Title - Sujet Ctr.Pier Repair, Wood Isl. Ferry,PE	
Solicitation No. - N° de l'invitation ED001-162024/A	Amendment No. - N° modif. 004
Client Reference No. - N° de référence du client R.077637.001	Date 2016-01-13
GETS Reference No. - N° de référence de SEAG PW-\$PWC-021-3781	
File No. - N° de dossier PWC-5-38180 (021)	CCC No./N° CCC - FMS No./N° VME
Solicitation Closes - L'invitation prend fin at - à 02:00 PM on - le 2016-01-20	Time Zone Fuseau horaire Atlantic Standard Time AST
F.O.B. - F.A.B. Plant-Usine: <input type="checkbox"/> Destination: <input checked="" type="checkbox"/> Other-Autre: <input type="checkbox"/>	
Address Enquiries to: - Adresser toutes questions à: Donovan, Janine E.	Buyer Id - Id de l'acheteur pwc021
Telephone No. - N° de téléphone (506) 636-5347 ()	FAX No. - N° de FAX (506) 636-4376
Destination - of Goods, Services, and Construction: Destination - des biens, services et construction:

This Solicitation Amendment No. Four (4) is raised to include the following addendum no. 4.

Addendum 4.

Question 3: Ref: Dwg S4 of 4- Detail 6, Section A and B, Detail 2

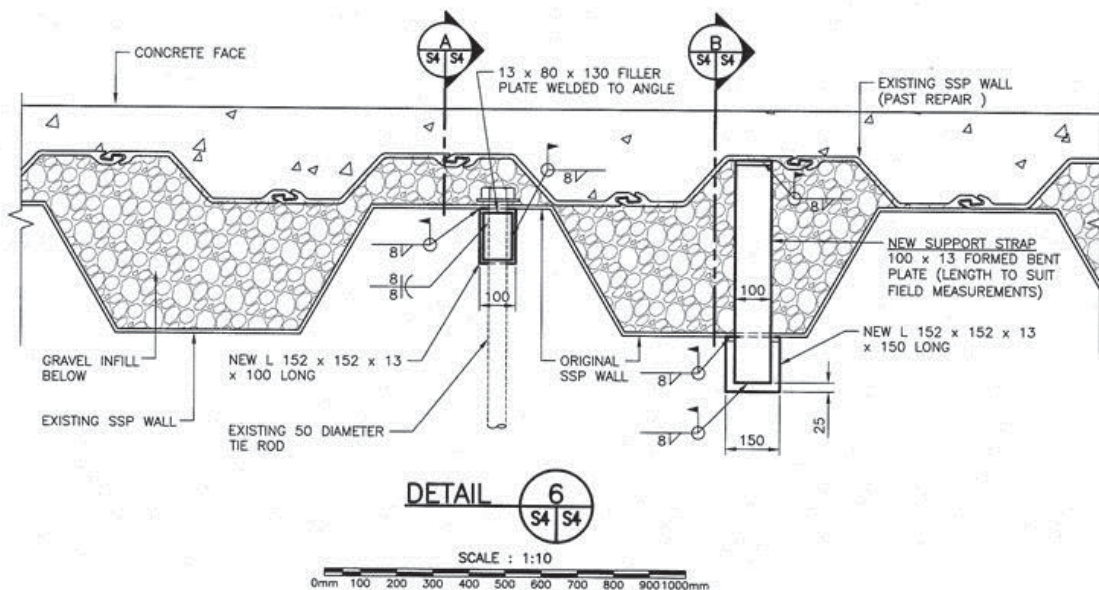
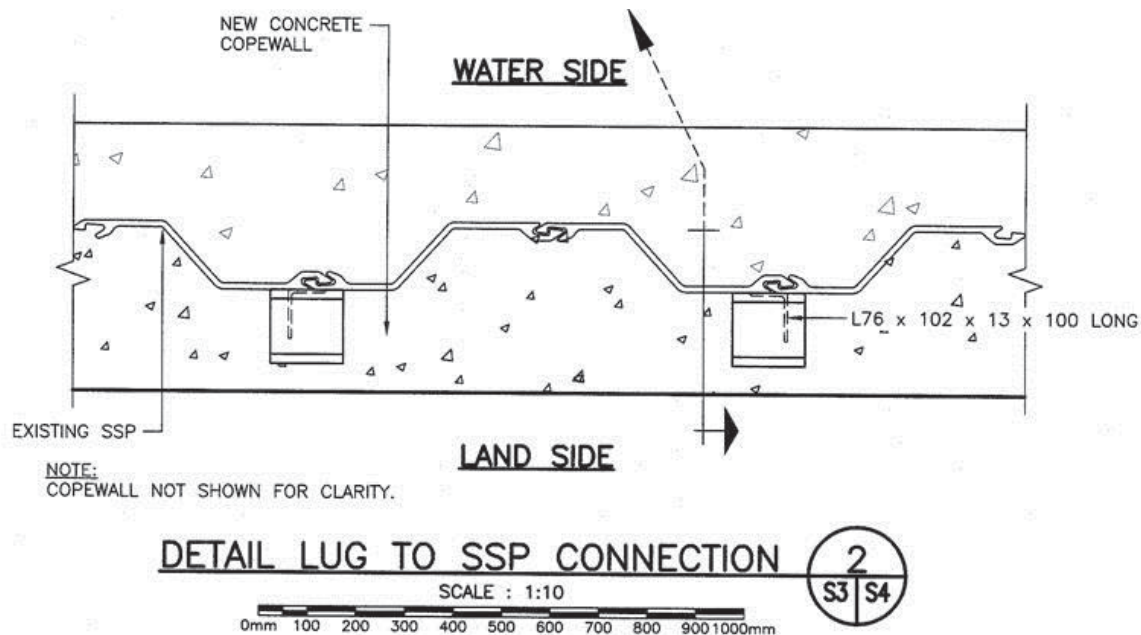
Please confirm the spacing of the lugs shown in Detail 2. Also please confirm if the support strap shown in detail 6 shall only be installed adjacent to the Existing 50mm tie rods (1905mm spacing), or if there is a different regular spacing.

Answer 3: See responses below, referencing the above shown details:

1. Detail 2/S4, Add the following note. "INSTALL LUGS ON EACH SSP IN-PAN (APPROX. SPACING 950MM+/-)"
2. Detail 6/S4, Add the following note. "ONE NEW SUPPORT STRAP IS REQUIRED PER TIEROD"
